Information note

N° 10269AERRA

Errata sheet V1.9 affecting products TC39x_BC

Subject Errata sheet V1.9 affecting products TC39x_BC

Figure 2 Message buffer transfer from Message RAM to OBF

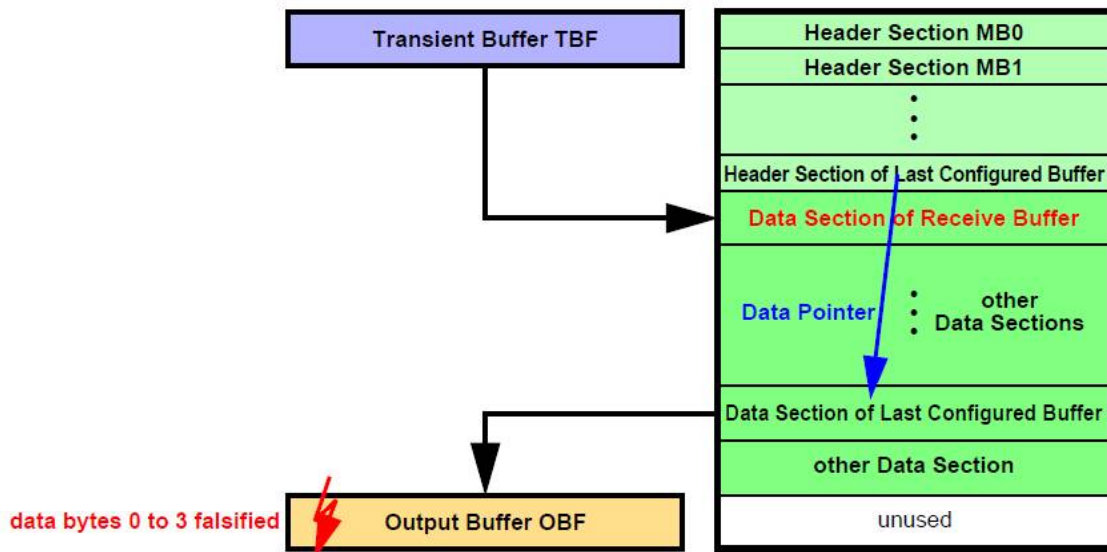
When the message buffer has its payload configured to maximum length (**PLC** = 127), the OBF word on address 00h (payload data bytes 0 to 3) is overwritten with unexpected data at the end of the transfer.

a) When a message is transferred from the Last Configured Buffer in the Message RAM to the OBF and **PLC** = 127 it may happen, that at the end of the transfer the OBF word on address 00h (payload data bytes 0 to 3) is overwritten with unexpected data (see [Figure 2](#)).

Figure 3 Message buffer transfer from IBF to Message RAM

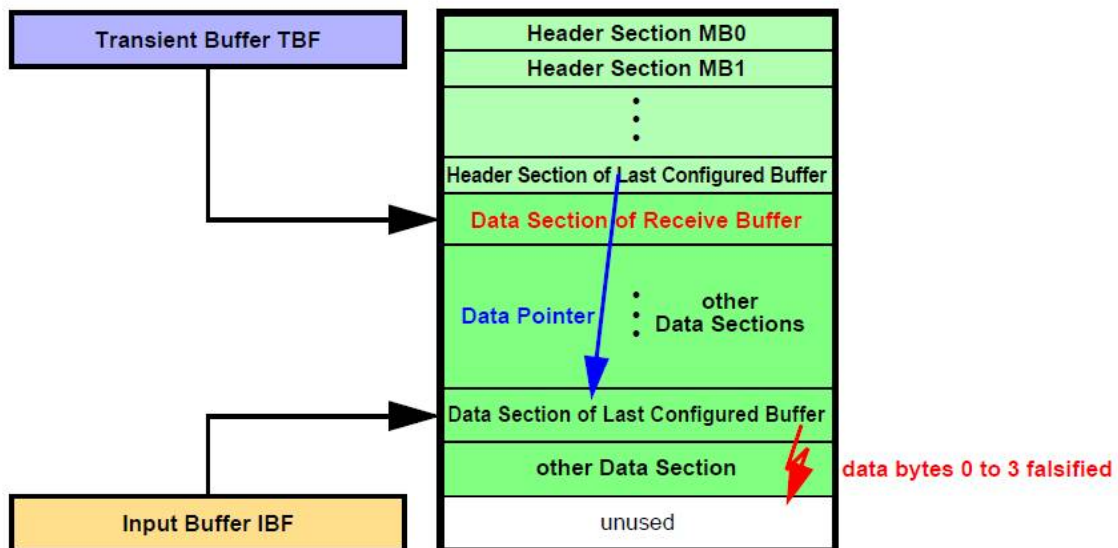
After the Data Section of the selected message buffer in the Message RAM has been written, one additional write access overwrites the following word in the Message RAM which might be the first word of the next Data Section.

b) When a message is transferred from IBF to the Last Configured Buffer in the Message RAM, it may happen, that at the end of the transfer of the Data Section one additional write access overwrites the following word, which may be the first word of another message's Data Section in the Message RAM (see [Figure 3](#)).

Figure 4 Message RAM Configurations

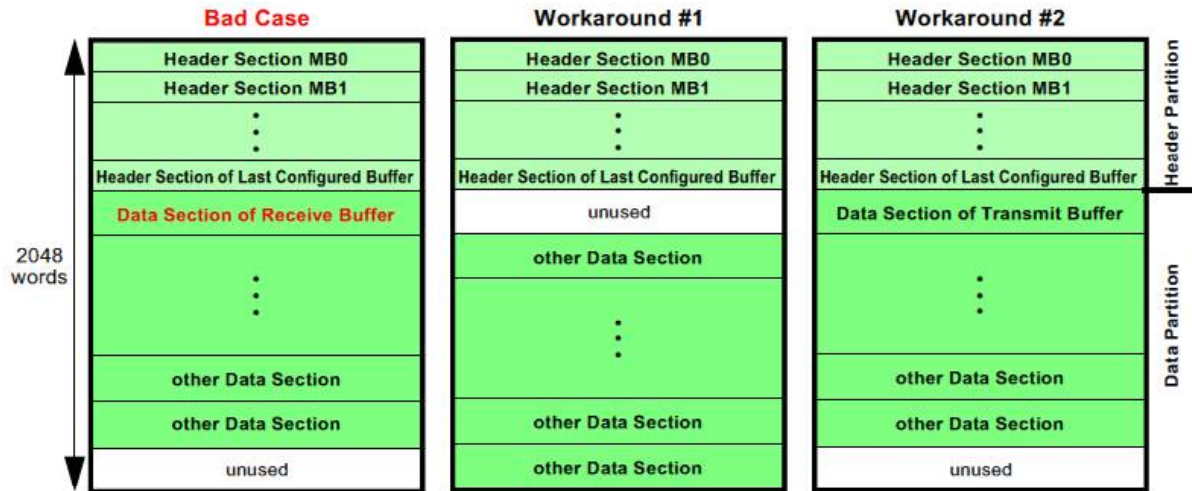
The erratum is limited to the case when (see [Figure 4](#) “Bad Case”):

2) Ensure that the Data Section directly following the Header Partition is assigned to a transmit buffer.

Figure 6 MCS AEI master access path

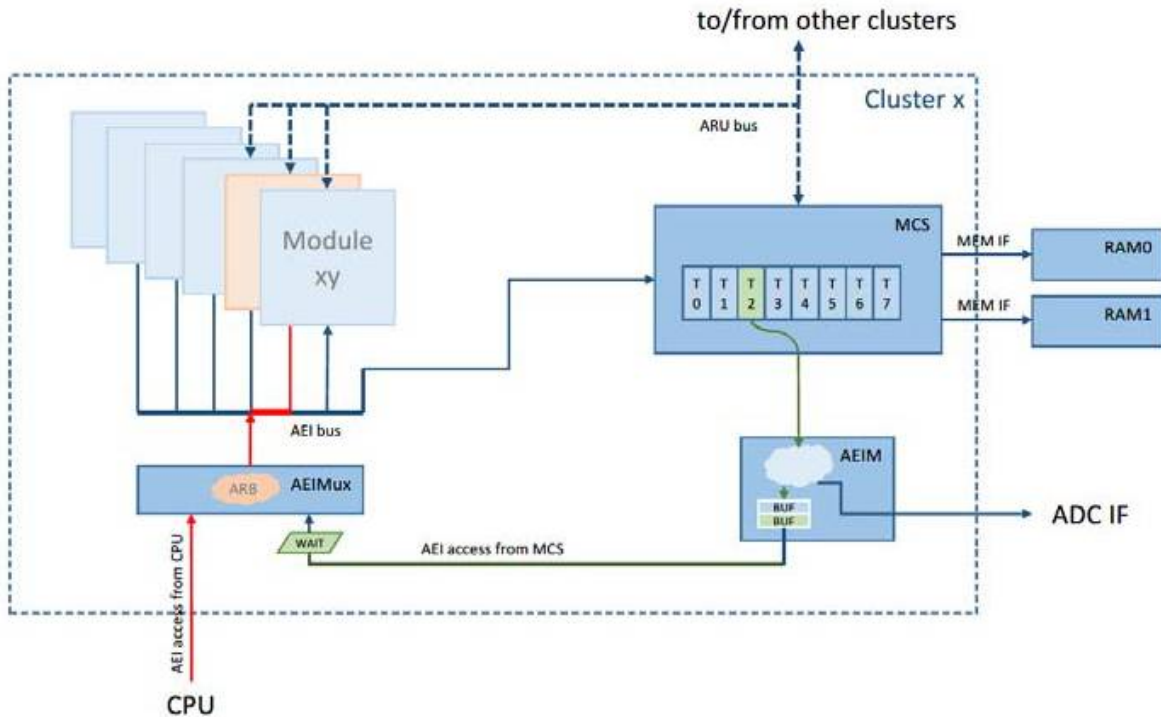
Figure 6 shows an uncritical traffic situation. Here an access of a MCS thread to the AEI bus (green access path) is temporary delayed due to an ongoing AEI bus access from the CPU (red access path). The MCS access to the AEI bus will be safely buffered at the AEIM (green buffer). As soon as the CPU access to the AEI bus completes, the buffered AEI bus access from MCS will be executed.

Figure 7 Critical MCS AEI master scenario

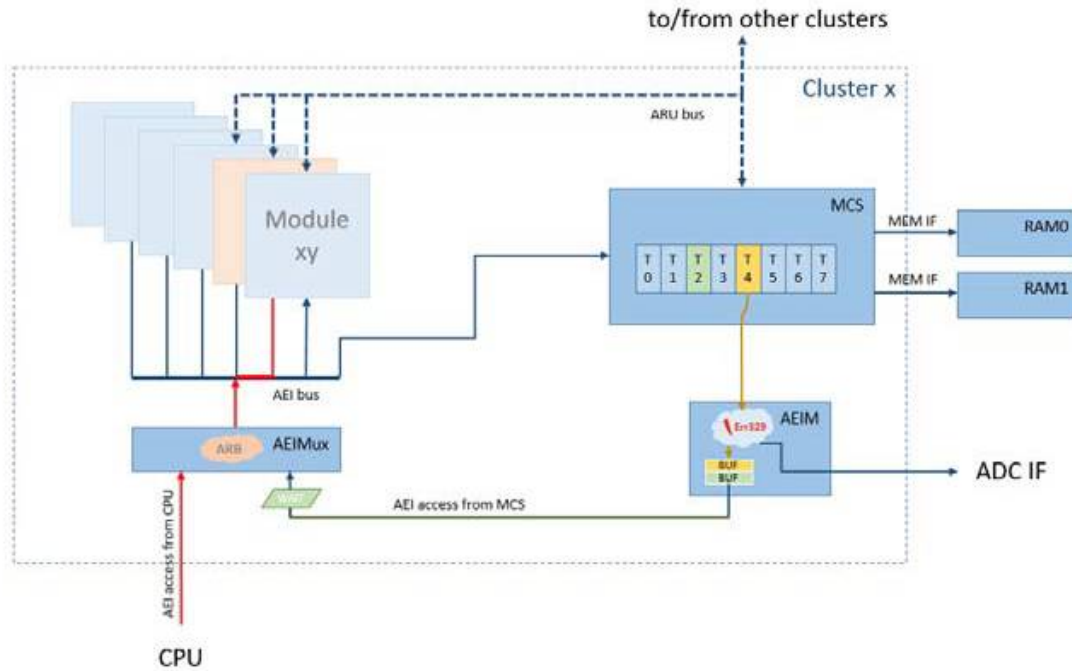
In [Figure 7](#), a potential risk for the occurrence of problem GTM_AI.329 is illustrated. Here the first buffer of the AEIM (green) is still waiting for the access to the AEI bus while a second AEI bus access from MCS arrives at the AEIM (yellow access path). Under certain, but for the user unpredictable timing conditions, this second AEI bus access arriving at the AEIM can trigger the misbehavior described in problem GTM_AI.329.

The workarounds described in the following section will ensure that not more than one AEIM buffer will be filled and therefore the occurrence of problem GTM_AI.329 is avoided. All workarounds have been tested and proven correct.

Figure 9 Equivalent Circuitry for Analog Inputs

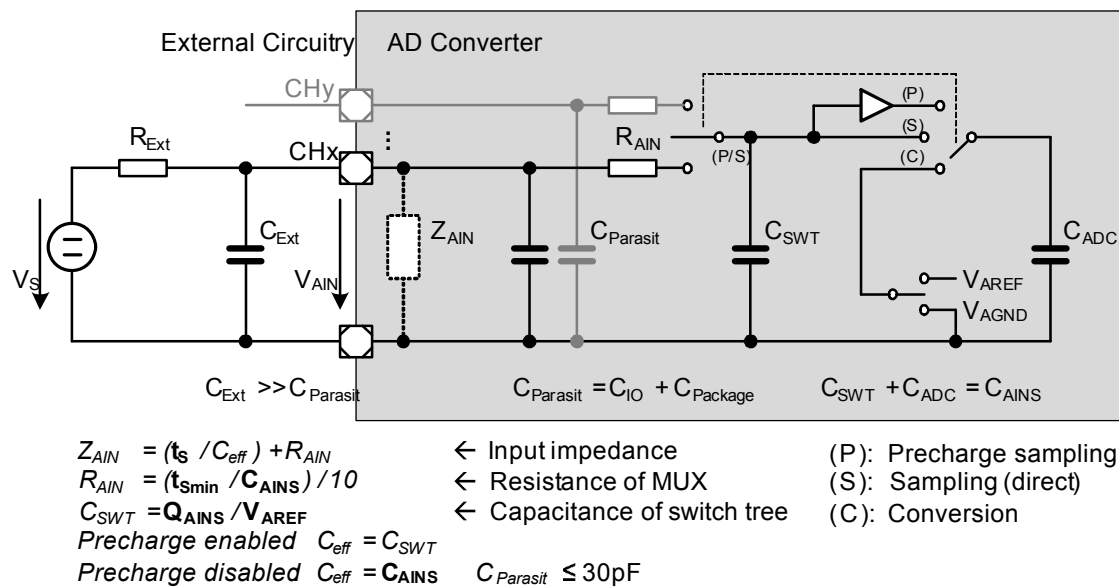
Figure “Equivalent Circuitry for Analog Inputs” will be modified in future revisions of the Data Sheet, including the term $C_{\text{Parasit}} \leq 30 \text{ pF}$, as shown in the following figure:

Figure 10 Interrupt Level vs. Pulse-Notify mode - Corner Case Example

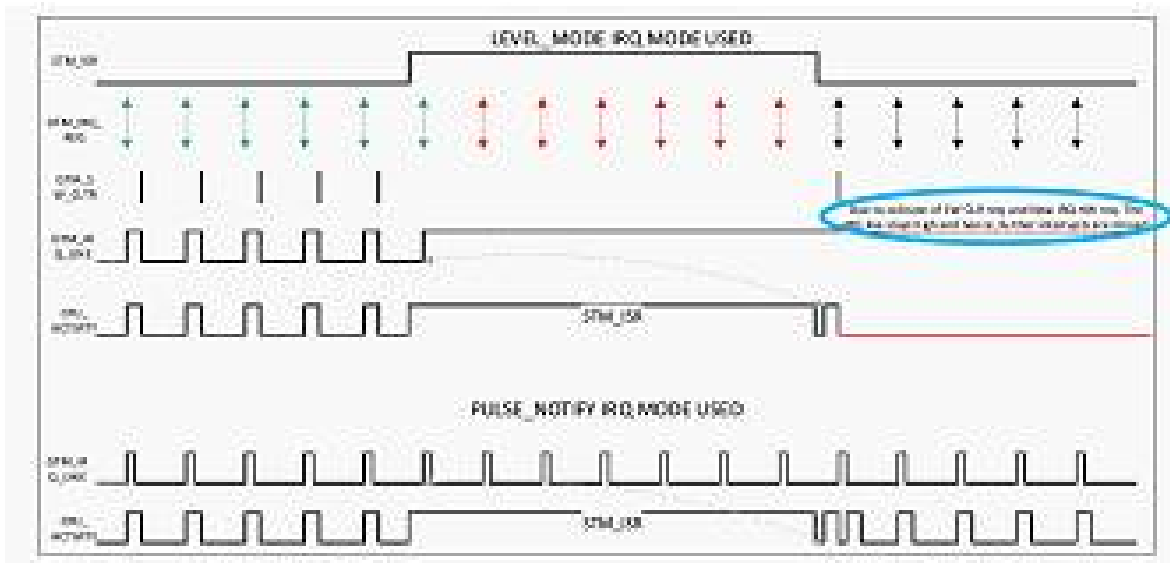
Hence, in Level Mode, in some scenarios where another interrupt request is generated by GTM while the ISR handle also requests a SW clear, then, as the interrupt event is dominant over the clear event (for simultaneous interrupt and clear events), GTM_IRQ_XXX is not cleared and remains high. As a consequence, the IR observes no transition on GTM_IRQ_XX. Thus, any forthcoming interrupt events in this scenario are lost as there is no chance to release the CPU IRQ when a collision happens as shown in Figure below.

If Pulse-Notify mode is selected, every internal trigger will be forwarded to the IR, irrespective of the time of occurrence and the clear event, as the pulse-notify leads to set and reset of GTM_IRQ_XXX as compared to only setting of the GTM_IRQ_XXX line in Level mode.

Figure 12 Timing of LVDS TX interface command sending in relation to IRQ.IFCFS

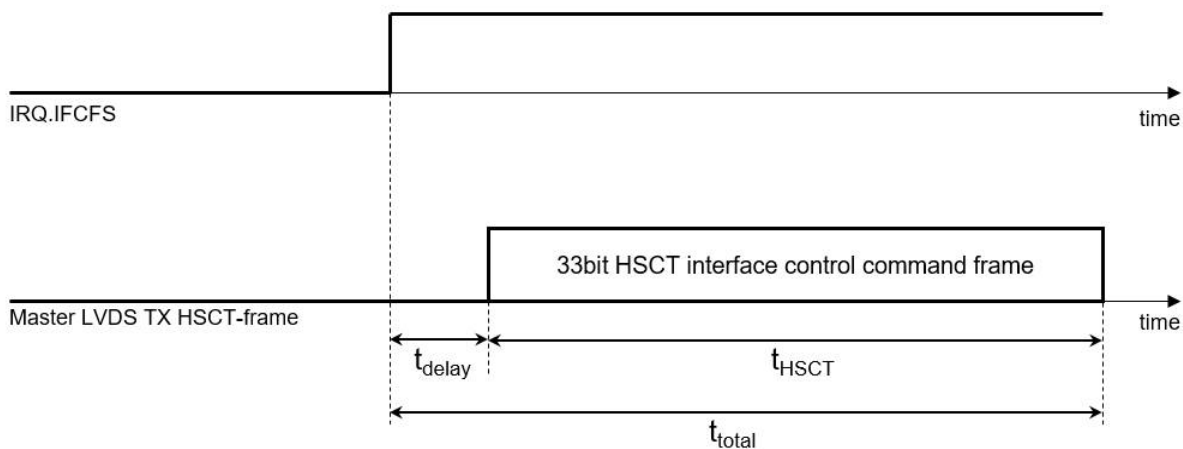
the user might falsely assume that also the actual sending on the LVDS TX port has already occurred once the IRQ.IFCFS flag is set, which is not true.

Instead the timing shown in **Figure 12** applies.

Figure 13 ADC Trigger Concept

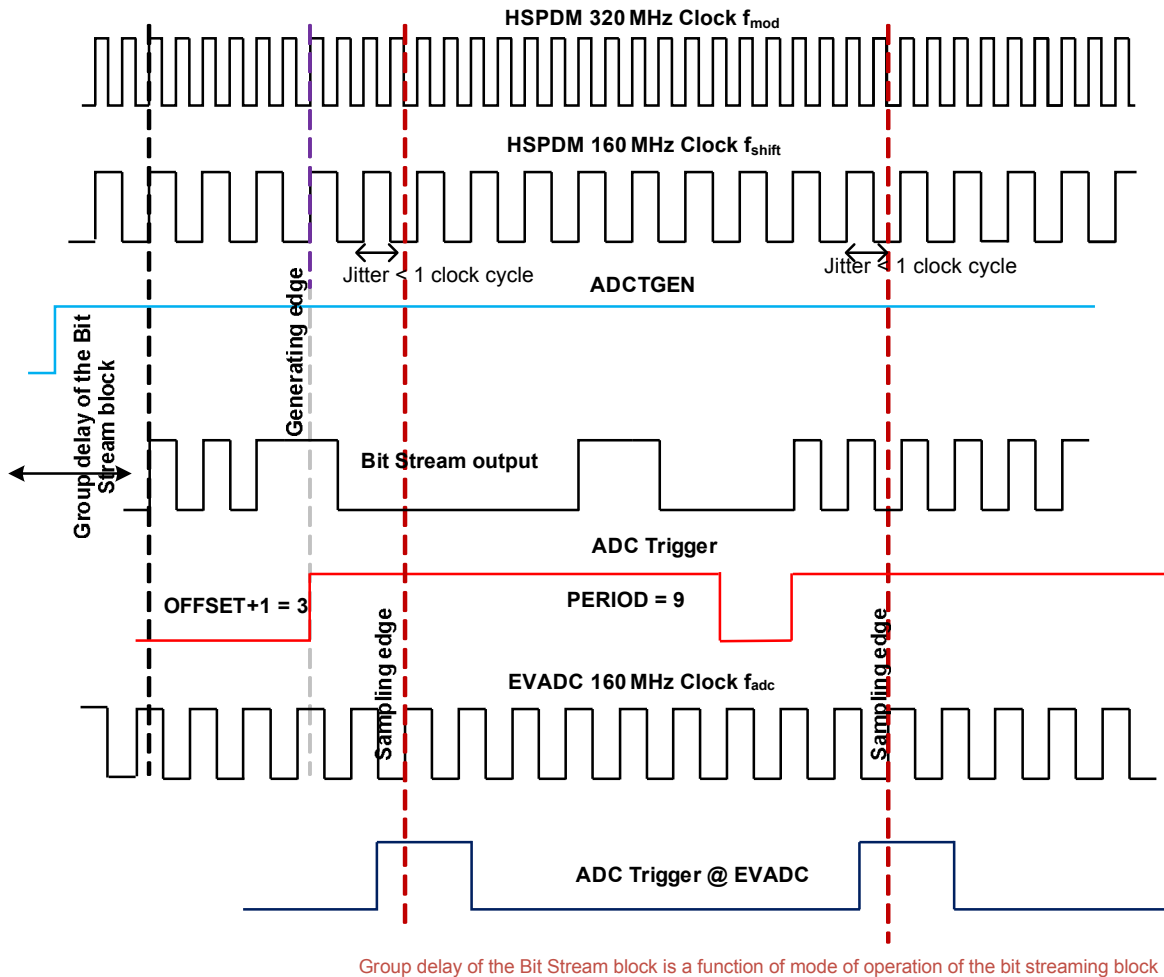
HSPDM_TC.H004 ADC Trigger Concept - Figure update

Figure “ADC Trigger Concept” in the current version of the HSPDM chapter of the TC3xx User’s Manual shall be replaced with the following updated figure:

Figure 14 SDIO Card Interrupt Sequence

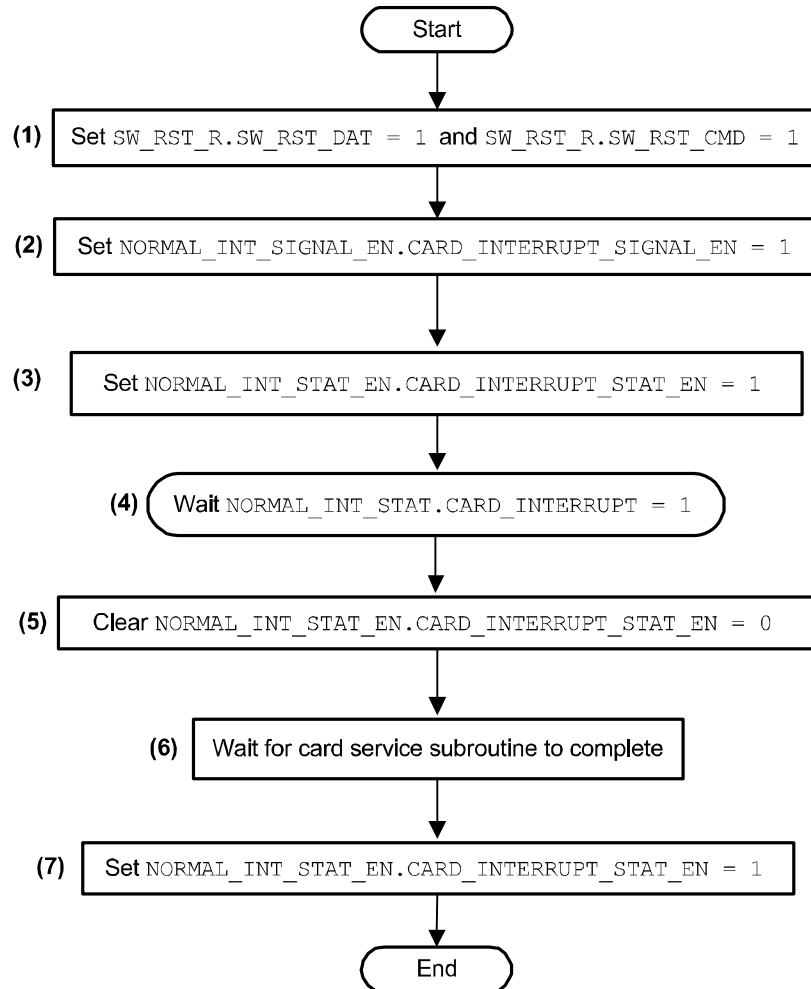
SDMMC_TC.H002 SDIO Card Interrupt Sequence - Figure update

Figure “SDIO Card Interrupt Sequence” in the SDMMC chapter of the current version of the TC3xx User’s Manual is wrong. The correct sequence is shown in the following **Figure 14**.
